# DEPARTMENT OF TRANSPORTATION

**SUBJECT: Addendum No. 2**  
**Wentworth Springs Road at Gerle Creek – Bridge Replacement**  
**Project**  
**Contract No. PW 11-30573, CIP No. 77118**

**GENERAL PLAN**

SHEET  
**S-1**  
6 OF 13  
W.O. No. 77118

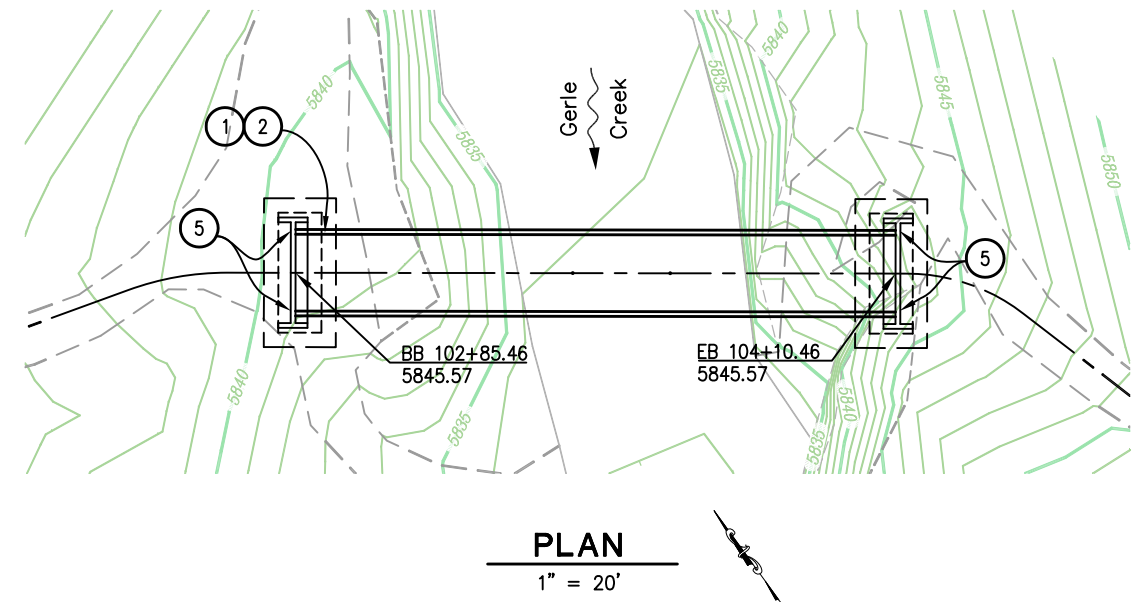
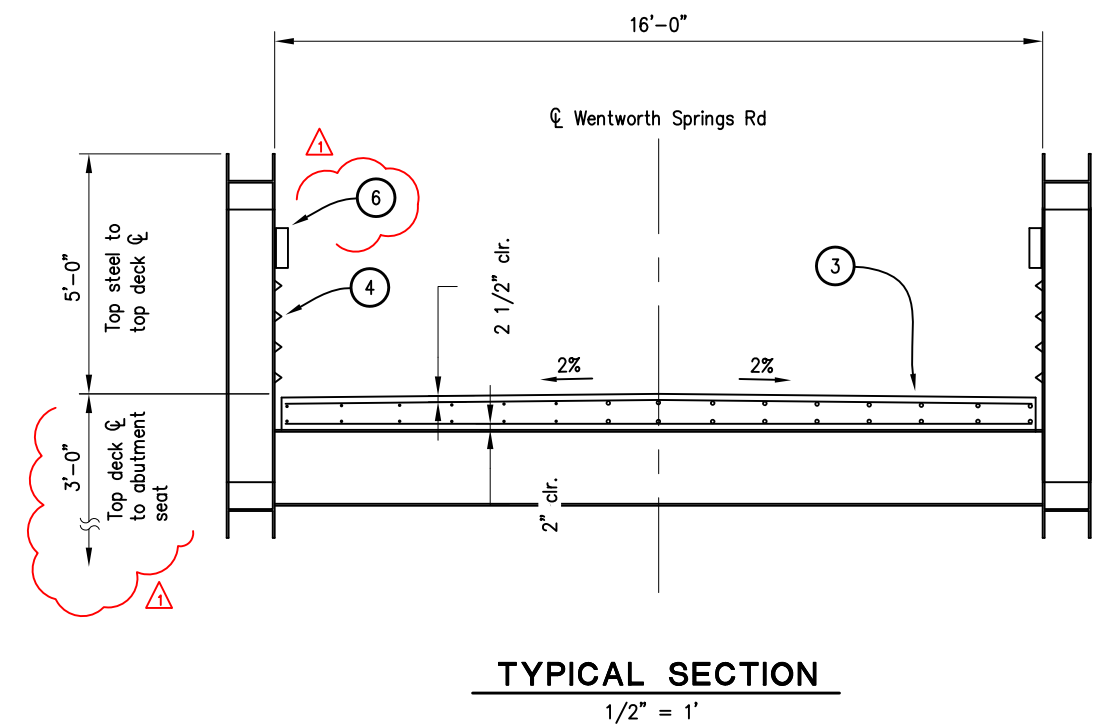
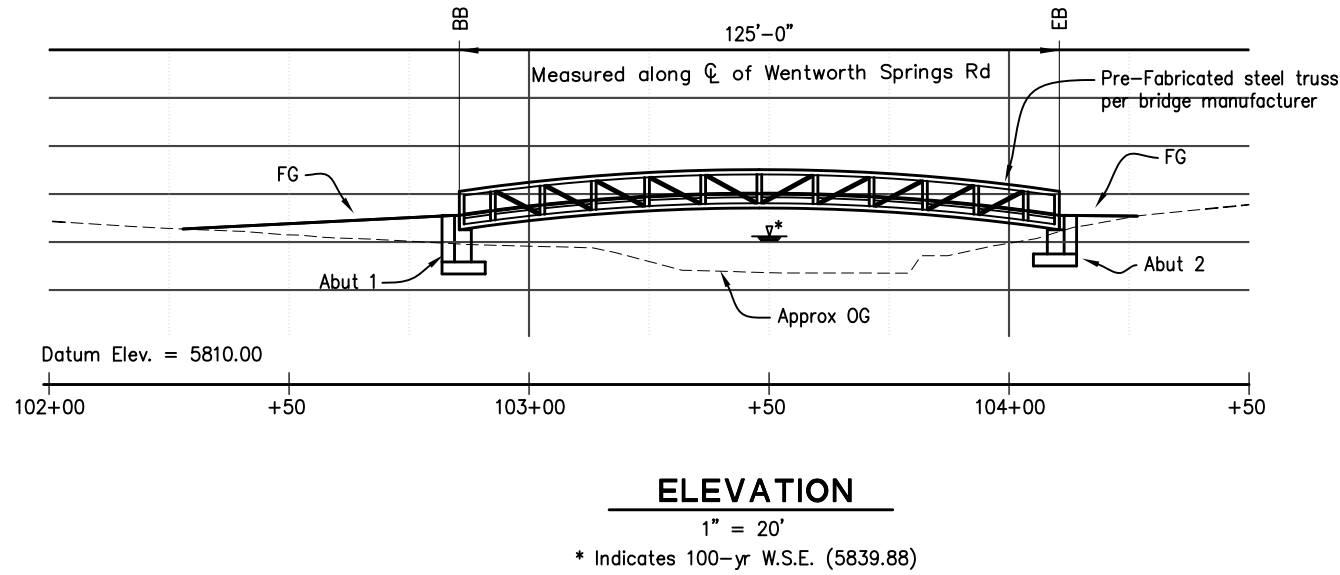
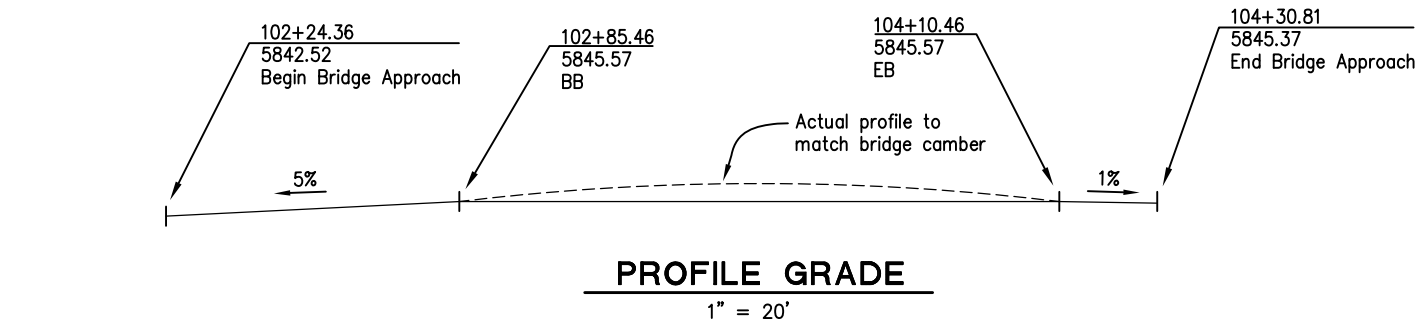
2.02	Plan Sheet S-1	<b>Questions:</b> An 8ft truss height will be difficult to design for the loads and meet the 400k maximum dead load reaction. Is a taller truss allowed as long as the 3'-0" low steel is held? <b>Answer:</b> The County will accept designs for a taller truss as long as the low steel dimension is maintained in accordance with 2.02 of this Addendum and the design reactions are not exceeded.

2.03	Plan Sheets S-1 and S-5	<b>Questions:</b> The project specifications limit the abutment backwall height to 3'-0" while the drawings show a 3'-0" top of deck to low steel dimension. <b>Answer: Bidders are instructed to replace Plan Sheet 6 of 13 (S-1) with revised Plan Sheet 6 of 13 (S-1) attached to this Addendum.</b>

2.04	Plan Sheet S-1 and SP-75	<b>Question:</b> Are there going to be any vehicular rail requirements on this bridge structure? While CALTRANS style barriers are likely not required on a structure of this type, we would normally recommend some type of more substantial railing element between the roadway and truss (potentially a

<p>10" high tubular or HSS member), in addition to the angle safety rails, and designed for some lateral impact load (say 10 kips).</p> <p><b>Answer: Bidders are instructed to replace Plan Sheet 6 of 13 (S-1) with revised Plan Sheet 6 of 13 (S-1) attached to this Addendum.</b></p> <p>Add the following after last sentence of 2nd to last paragraph on SP-75 of <b>Section 10-1.19 "Pre-fabricated Steel Truss Bridge"</b>:</p> <p><i>"A guard railing made of hollow structural steel and measuring 10-inches in depth shall be installed approximately 40-inches above the top of deck on the inside of both trusses. The railing shall be designed to withstand a horizontal impact load of 10 kips."</i></p>

REVISION	NUMBER	DATE	DESCRIPTION	BY
1	4/4/12		REVISED LOWER TRUSS DIMENSION CALL-OUT; ADDED GUARD RAILING.
